Subject ▶ Addition of a Screw to Fasten Housing Set

For Models ▶ 6903VD,6903VDW(Cordless Impact Drivers) & 6907D(Cordless Impact Wrench)

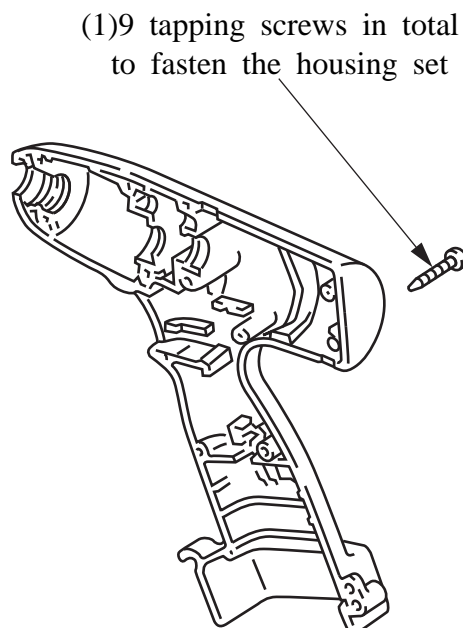
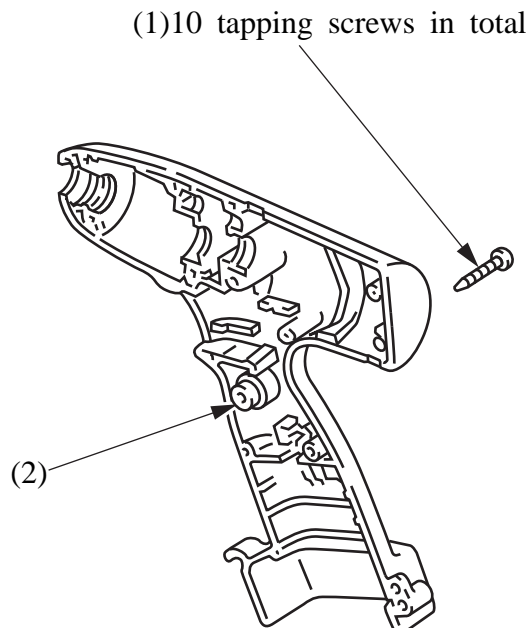
The tapping screws to fasten the housing set are all the identical

(1)A tapping screw is added to fasten the grip area of the housing set more securely.

(2)A projection for the additional tapping screw is added to each half of the housing set.
